# UNITED STATES PATENT AND TRADEMARK OFFICE

APPLICATION NO.	FILING DATE	FIRST NAMED INVENTOR	ATTORNEY DOCKET NO.	CONFIRMATION NO.
10/037,325	01/03/2002	Harry W. Eberle III	(HWE-107A)	5841

<b>Office Action Summary</b>	<b>Application No.</b>	<b>Applicant(s)</b>	
	10/037,325	EBERLE, HARRY W.	
	<b>Examiner</b>	<b>Art Unit</b>	
	Ernesto Garcia	3679

## **DETAILED ACTION**

6,363,677 (Chen et al.)

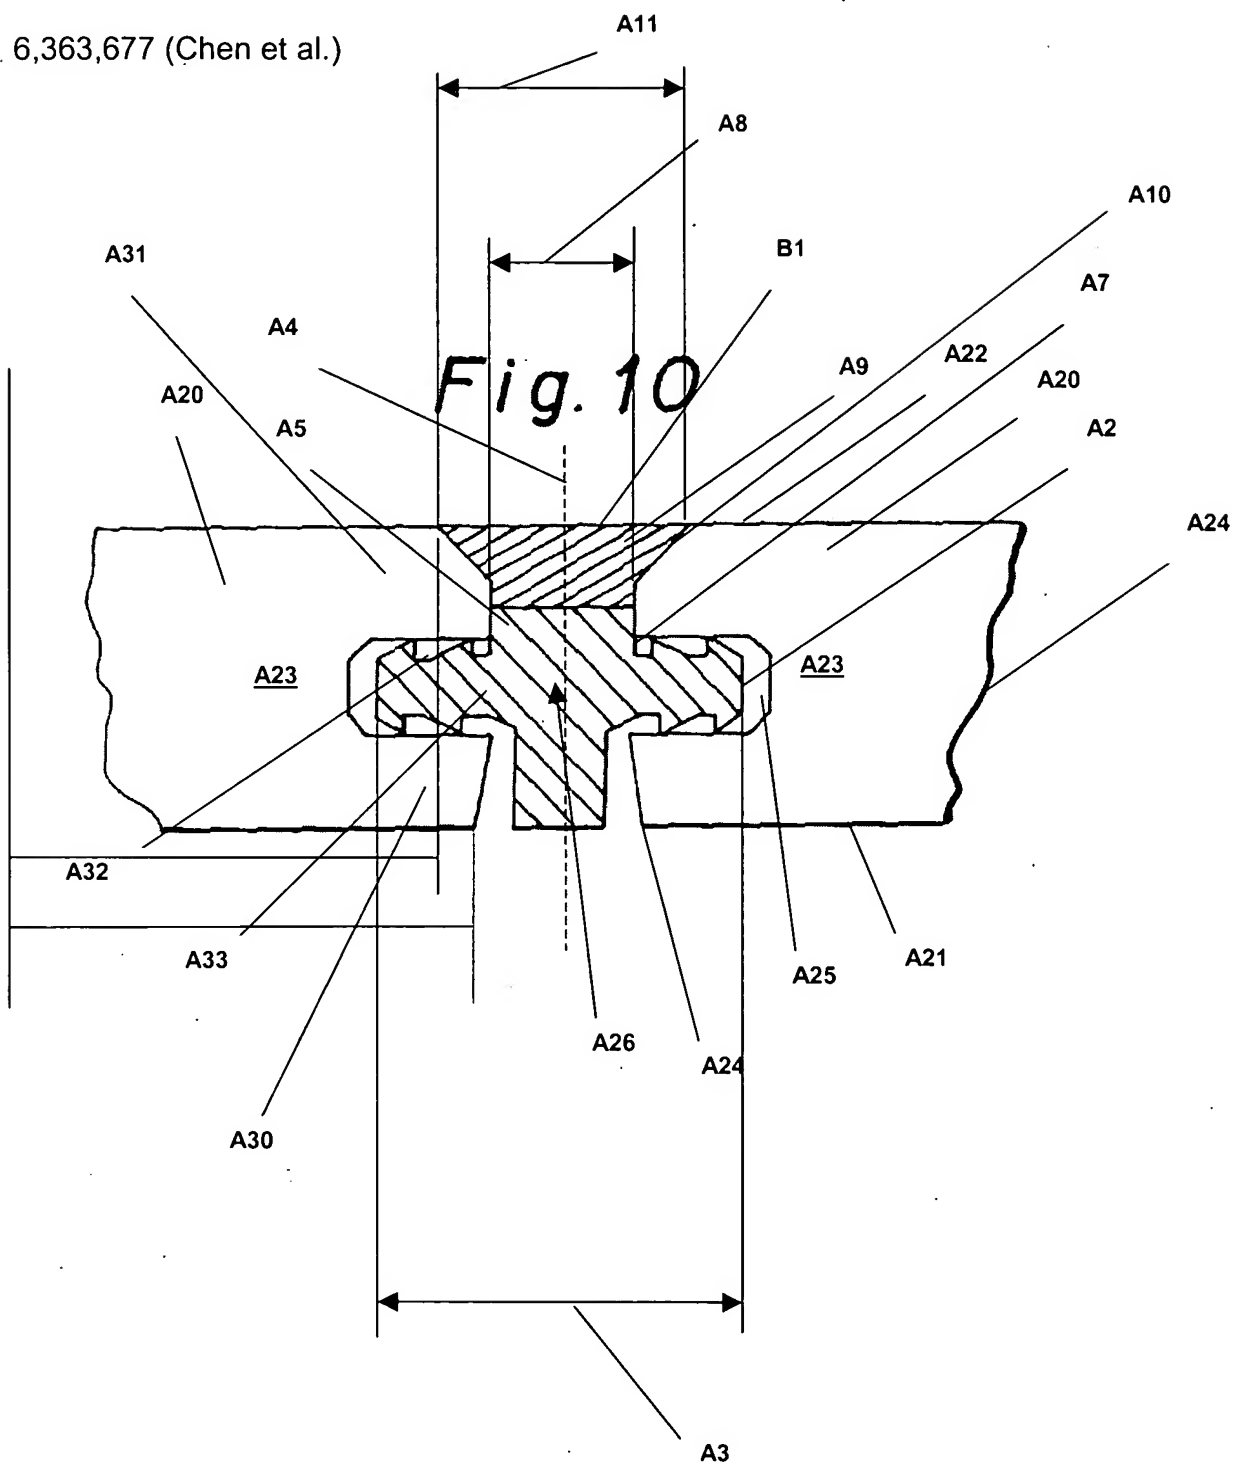
Claims 33 and 35-38 are rejected under 35 U.S.C. 102(e) as being anticipated by Chen et al., 6,363,677 (see marked-up attachment).

Regarding claim 33, Chen discloses in Figure 5, a decking system comprising boards **A20** and an anchoring device **A26**. Each of the boards **A20** has a top **A21**, a bottom **A22**, two sides **A23** and two ends **A24**. At least one groove **A25** is located along one of the sides **A23**. The anchoring device **A26** consists essentially of a substantially flat horizontal top element **A1**, at least one substantially vertical support member **A5**, and a substantially flat horizontal bottom element **A9**. The top element **A1** has a top view configuration including two sides **A2** and a predetermined first width **A3** as measured side to side. The first width **A3** is measured at a maximum width between the sides **A2**. The top element **A1** has an imaginary center line **A4**. The support member **A5** is attached to an underside **A6** of the top element **A1** along the center line **A4** and the support member **A5** extends downwardly therefrom. The support member **A5** has two sides **A7** and a predetermined second width **A8** as measured side to side at a maximum width. The bottom element **A9** has a flat bottom view configuration, which includes sides **A10**, and having a generally trapezoidal shape, and a predetermined third width **A11** as measured side to side at a maximum width at a trapezoidal base **B1**. The first width **A3** is greater than the second width **A8** and the third width **A11**. The third width **A11** is greater than the second width **A8**. The device is made of molded plastic material capable of having a metal fastener driven through (col. 7, lines 56-60).

Regarding claim 35, the two sides **A2** of the top element **A1** are symmetric to one another.

Regarding claim 36, the groove **A25** establishes an upper half **A30** of each of the boards **A20** above the groove **A25** and a lower half **A31** of each of the boards **A20** below the groove **A25**. The upper half **A30** has a greater width than the lower half **A31**. Compare widths **A32** and **A33**.

Regarding claim 38, the two sides **A2** of the top element **A1** are parallel to one another.

556,998 (Major)

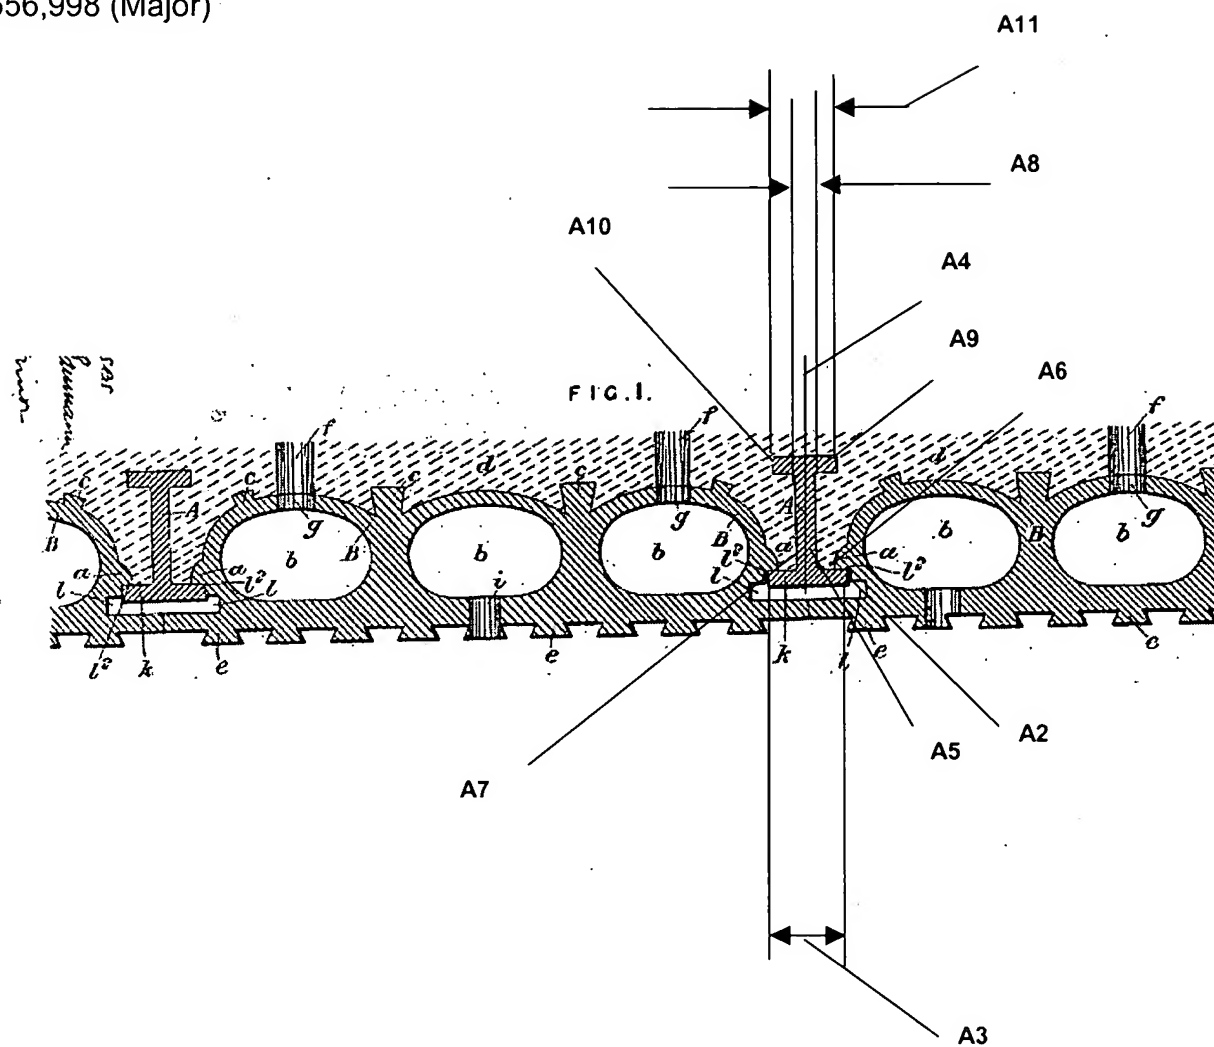
Claim 33 is rejected under 35 U.S.C. 103(a) as being unpatentable over Major, 556,998 (see marked-up attachment), in view of Fisher et al., 5,704,181.

Regarding claim 33, Major, discloses, in Figure 1, a decking system comprising boards **B** and an anchoring device **A**. Each of the boards **B** has a top **e**, a bottom **c**, two sides **I2** and two ends (Fig. 2A). At least one groove **I** is located along one of the sides **I2**. The anchoring device **A** consists essentially of a substantially flat horizontal top element **k**, at least one substantially vertical support member **A5**, and a substantially flat horizontal bottom element **A9**. The top element **k** has a top view configuration including two sides **A2** and a predetermined first width **A3** as measured side to side. The first width **A3** is measured at a maximum width between the sides **A2**. The top element **k** has an imaginary center line **A4**. The support member **A5** is attached to an underside **A6** of the top element **k** along the center line **A4** and the support member **A5** extends downwardly therefrom. The support member **A5** has two sides **A7** and a predetermined second width **A8** as measured side to side at a maximum width. The bottom element **A9** has a flat bottom view configuration, which includes sides **A10**, and a predetermined third width **A11** as measured side to side at a maximum width at a

However, Major, fails to disclose, the bottom element **A9** having a generally trapezoidal shape, and making the anchoring device **A** of molded plastic material.
